**CURATIVE AMMENDMENT FOR APPLICATION FOR
LICENSE (302-AM)**

WVOZ-AM AGUADILLA, PUERTO RICO

BL-20180911ADH (CP:BP-20170327AAF)

Changes made to EE -Proof of Performance:

SUMMARY OF MEASURED FIELD STRENGTH DATA

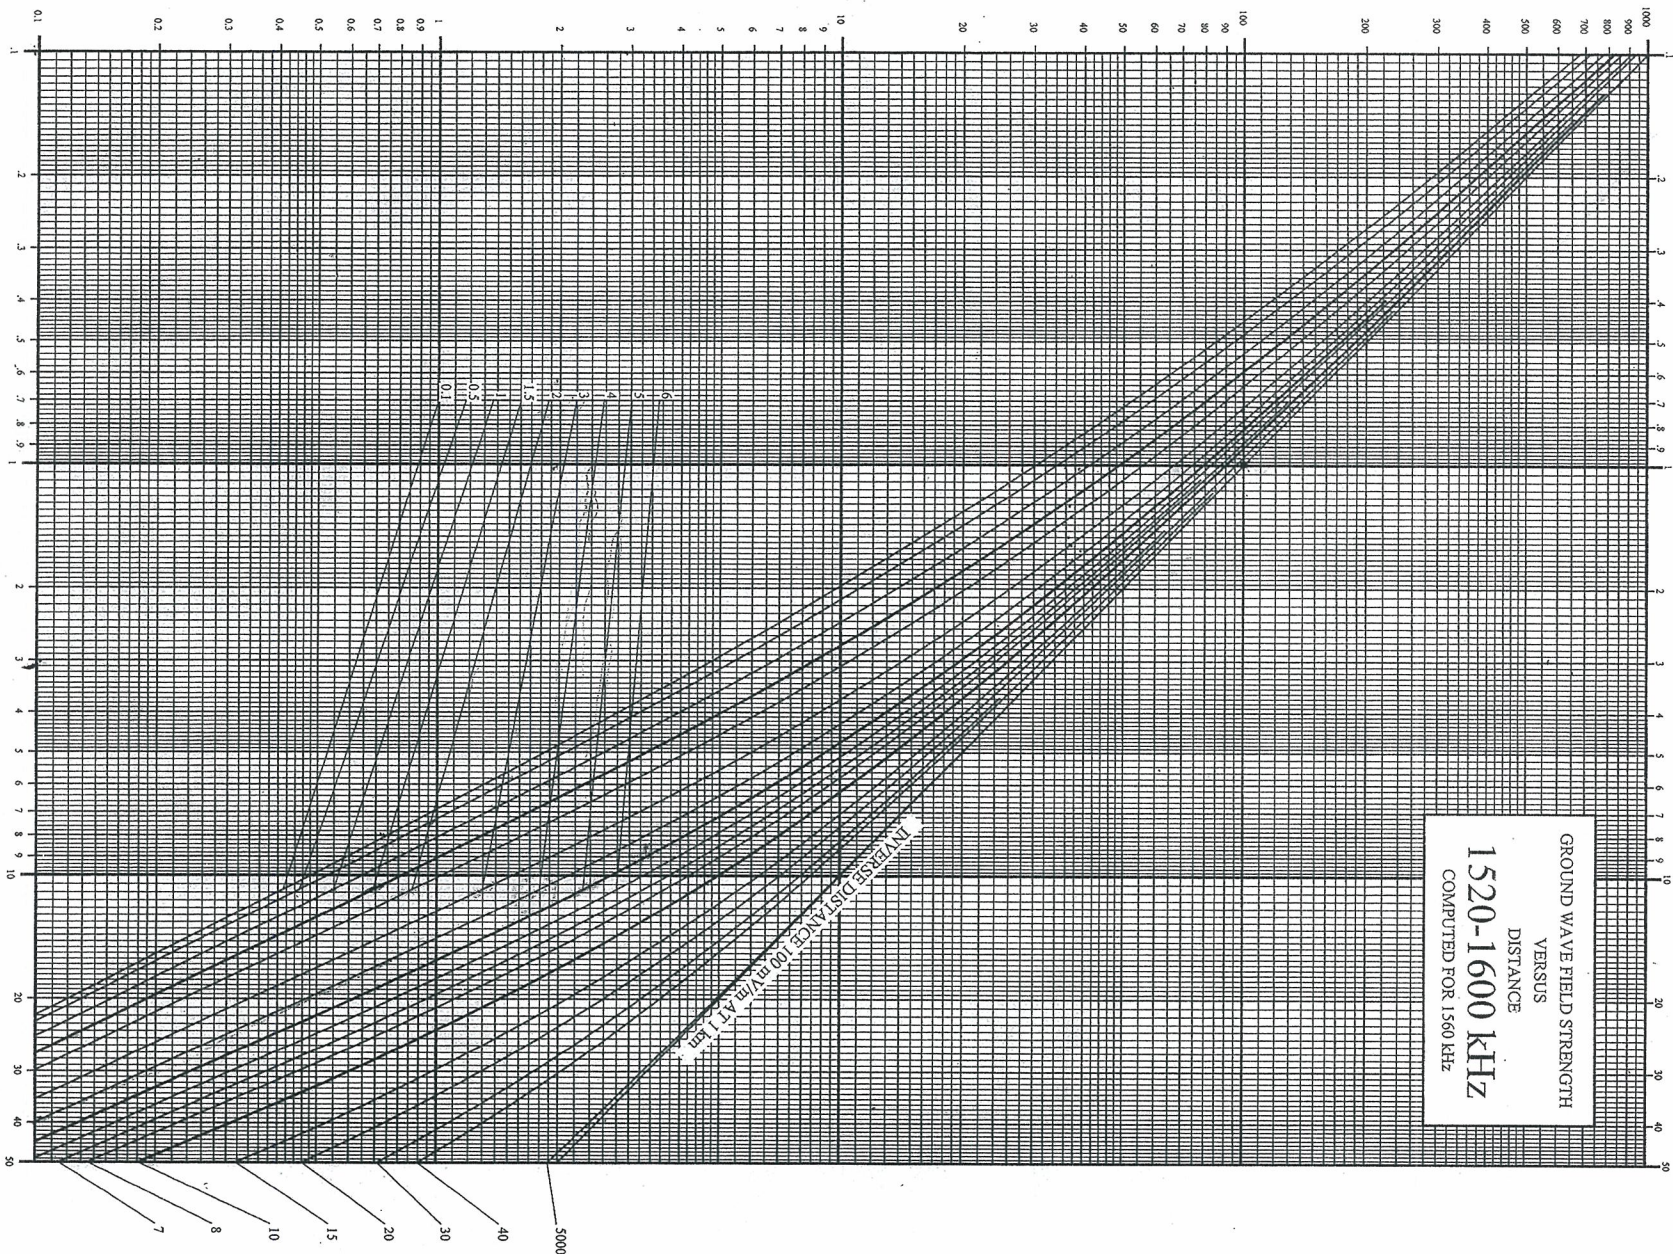
#2: In addition a new Figure 2 (Sheet 2 of 2: Summary of measured field strength data) is being supplied. The substitute page has a new column "IF FIELD Non-DA" containing the values

for each radial. Please use this page instead of the originally supplied.

GROUND WAVE FIELD STRENGTH
VERSUS
DISTANCE
1520-1600 KHZ
COMPUTED FOR 1560 KHZ

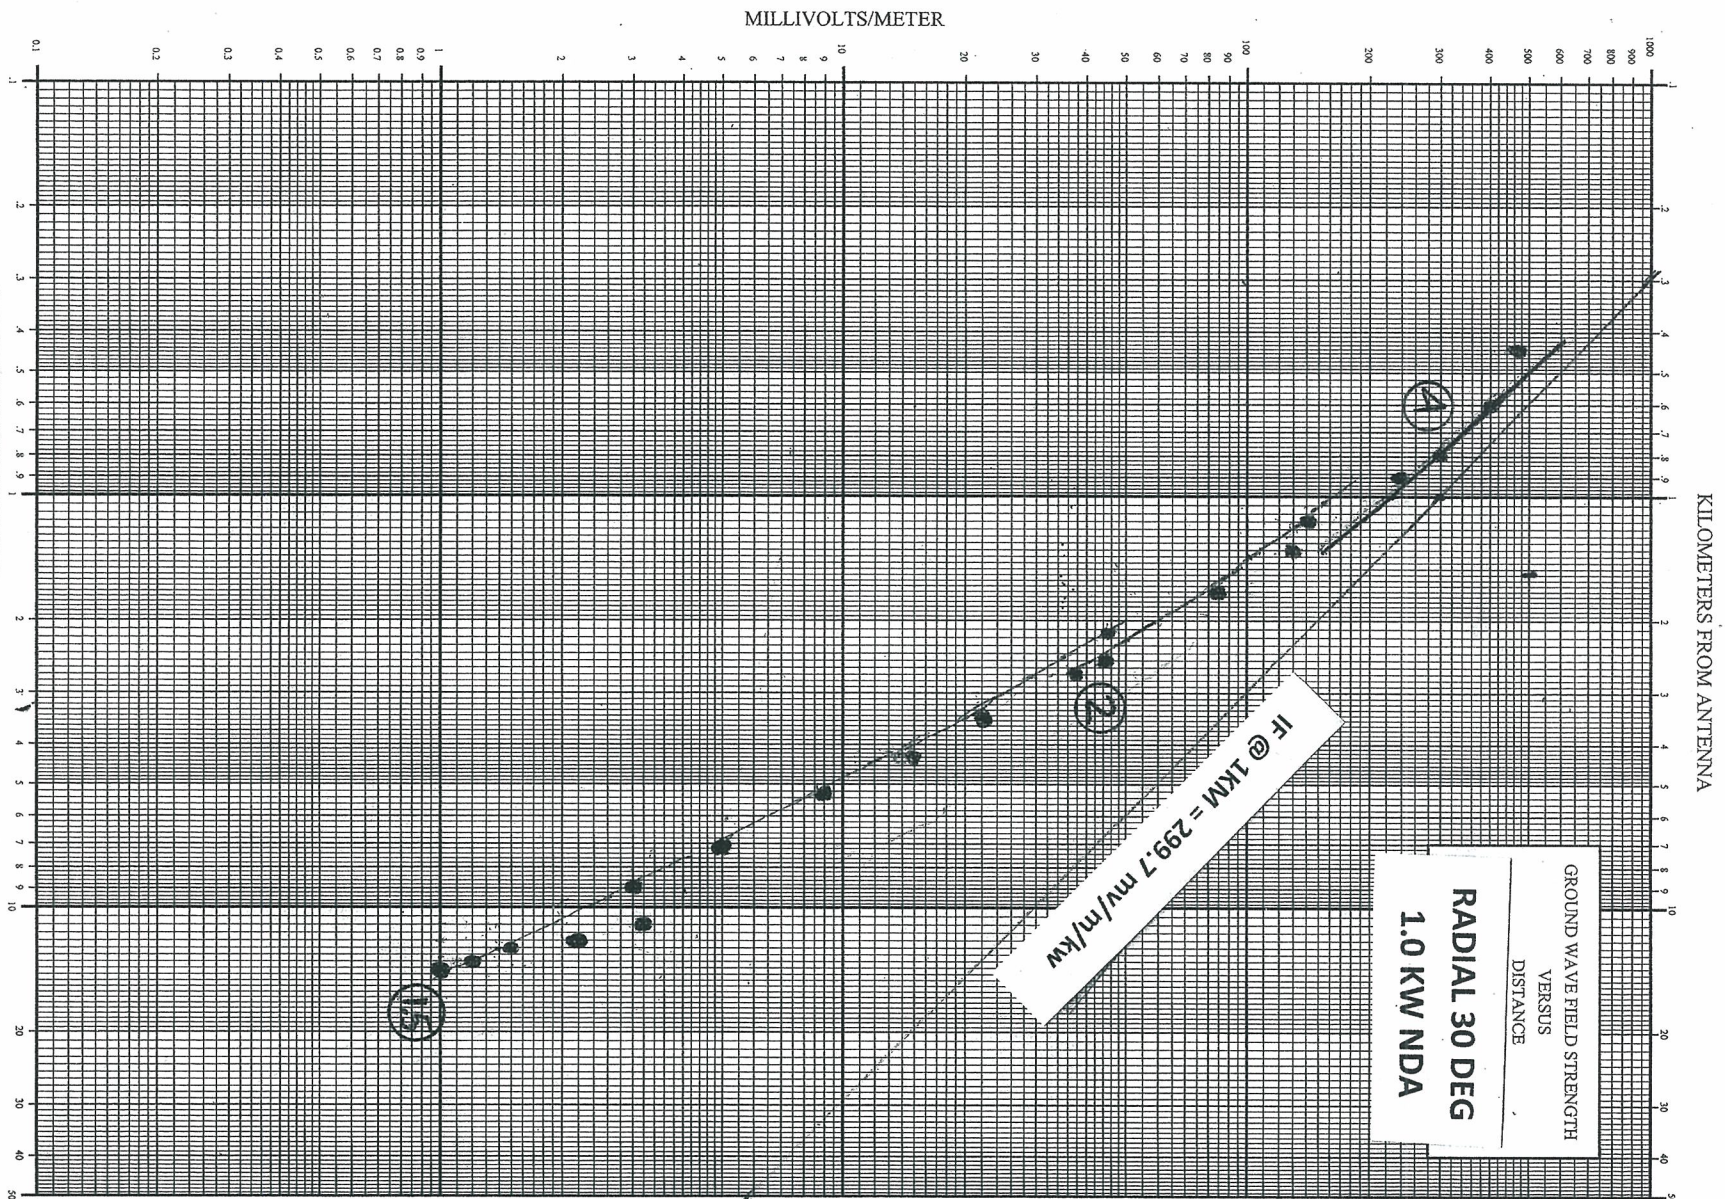
By this means, it is respectfully requested that the correct set of graphs along with the family of curves used to analyze them be made part of this curative amendment. (Please substitute the new set of graphs for each radial and insert Fig. 1 (Sheet 5A of 12: Family of curves for 1520-1600 downloaded from FCC page).
